# Access Compliance Report

## Public Rights-of-Way

### (Curb Ramps)

Intersection ID: 30342	Main Street: GOLD_PAN_RD	Cross Street: SANDBOAR_ST	Location: SE
ADA ID: BC2D494A6C29	Ramp Type: BlendTrans1	Initial Pass/Fail: Fail	Overall Compliance: No
Codes/Mitigation Info/Possible Solution			Severity Score: 10
			Field Measurements/Component Compliance

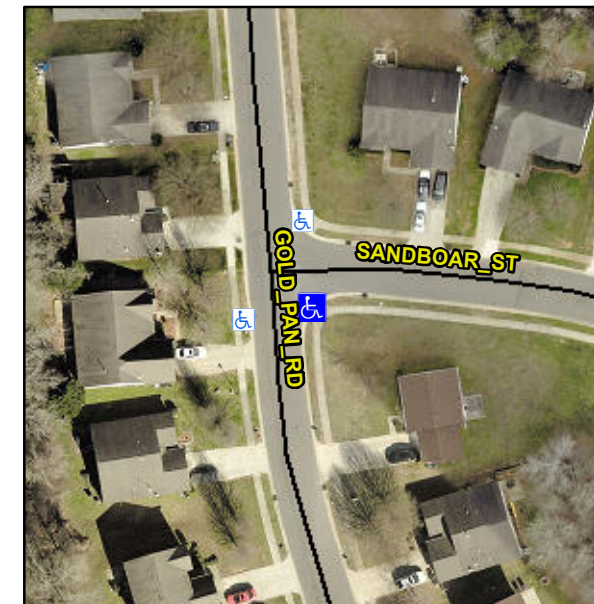
**Not Found, R304.5.1, R304.5.3**

Compliance	Description	Data	Compliance	Description	Data
N/A	Ramp Length (in)	55.0	Yes	BlendTrans Slope (%)	4.0
No	Ramp Width (in)	47.5	No	BlendTrans XSlope (%)	2.3
N/A	Flare Type LT	N/A	N/A	Flare Type RT	N/A
N/A	Flare Slope LT (%)	N/A	N/A	Flare Slope RT (%)	N/A
N/A	Flare Traversable LT?	N/A	N/A	Flare Traversable RT?	N/A
N/A	Landing Length (in)	N/A	N/A	DWS Provided?	N/A
N/A	Landing Width (in)	N/A	N/A	DWS Contrast?	N/A
N/A	Landing Slope (%)	N/A	N/A	DWS Length (in)	N/A
N/A	Landing X Slope (%)	N/A	N/A	DWS Full Width?	N/A
N/A	Landing Curb? (Y/N)	N/A	N/A	DWS Offset (in)	N/A
N/A	Shared Landing?	N/A			
N/A	Gutter Ponding?	N/A	N/A	Gutter Slope (%)	N/A
N/A	Gutter Lip Ht (in)	1.5	N/A	Gutter X Slope (%)	N/A
N/A	Painted X Walk1?	No	N/A	Painted X Walk2?	No
	X Walk 1 Direction	To N		X Walk 2 Direction	To W
	X Walk 1 Width (in)	N/A		X Walk 2 Width (in)	N/A
	X Walk 1 Slope (%)	0.7		X Walk 2 Slope (%)	1.4
	X Walk 1 X Slope (%)	3.1		X Walk 2 X Slope (%)	0.8

N/A	Ramp inside XWalk1?	N/A	N/A	Ramp inside XWalk2?	N/A
	Road Slope (%)	2.4		Clear Space?	N/A
	Road X Slope (%)	0.7	N/A	Clear Space to XWalk (in)	N/A
N/A	Any Obstructions?	N/A	N/A	Storm Grate/Utility Hazard?	N/A
	Obstruction Type			Storm Grate/Utility Type	
		N/A			N/A
			Yes	Surface Condition? (G/P)	Good
			No	Curb Slope (%)	16.0

**Remove & Replace Curb Ramp With Two New Directional Ramps or Equivalent.**
